TITLE: ESP32-C3 Supermini to DX-LR-30		REV: 1.0
EasyEDA	Company: rzident	Sheet: 1/1
	Date: 2026-05-17 Drawn By: rzident

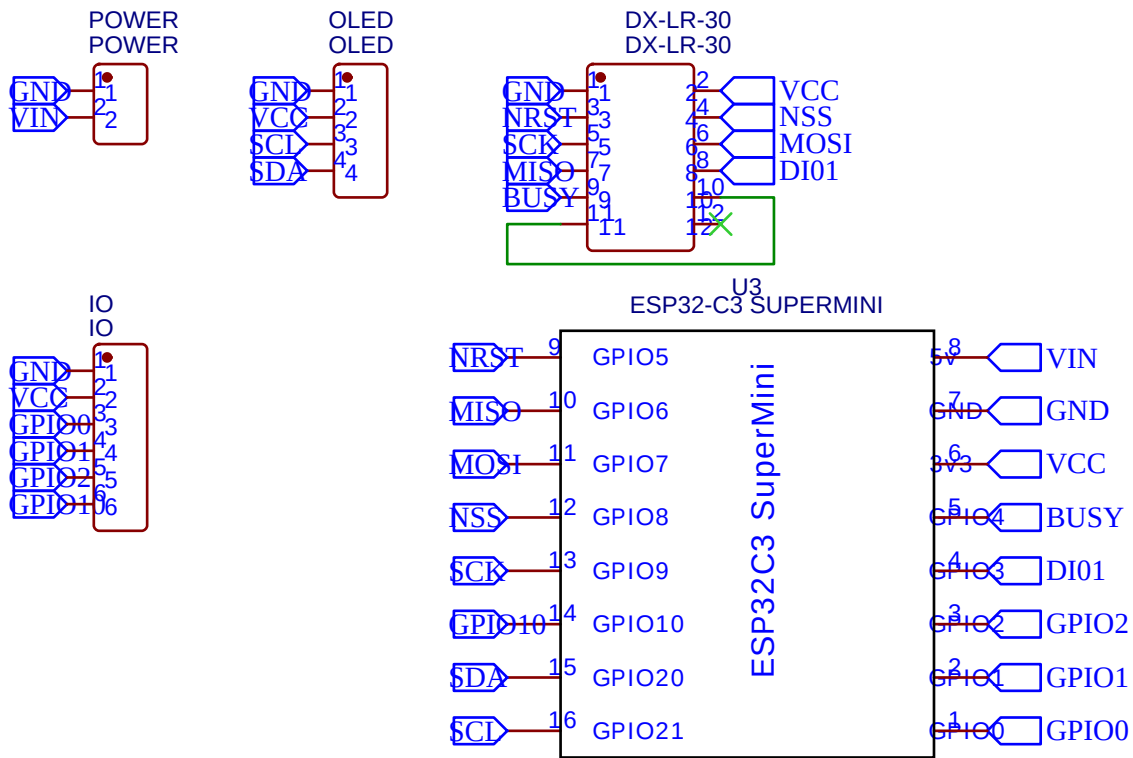
Schematic is not equal to heltec-ht62-esp32c3-sx1262; Idea was to match the HT-CT62
However, MOSI and SCK are swapped and GPIO8 is also used by the blue LED
Choice of GPIO8 is not smart: Is used by the onboard blue LED

This can be corrected when building the firmware but stock image cannot be used
